### 430.000 MHz OSCILLATOR

<b>Universal Electronics Inc.</b>  6101 Gateway Drive Cypress, CA 90630 Phone 714-820-1000 FAX 714-820-1010		Title <b>RF Transmitter Module</b> Size: A Number: UEIS-10265 Revision: 1 Design by: _____ Drawn By: 08/16/02	
File: H:\DESKTOP\Agile\10265_1.sch		Date: 19-Aug-2002 Time: 11:07:06 Sheet 1 of 1

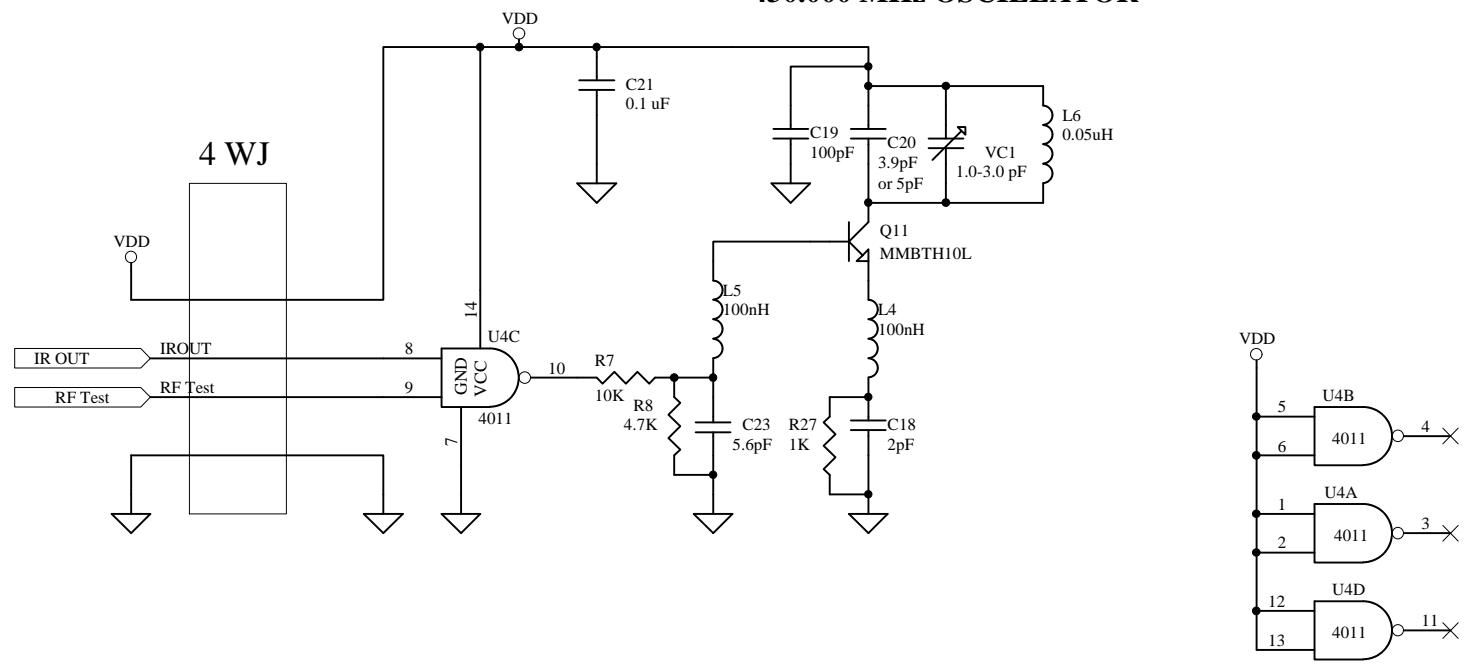
DOCUMENT REVISION STATUS							
ECO#	ZONE	REV.	DESCRIPTION OF CHANGE	Chgd. By	DATE	APPR.	DATE
		1	C21 = 0.1 uF to reduce VDD noise.	H.M.	08/12/02	J.M.	08/16/02
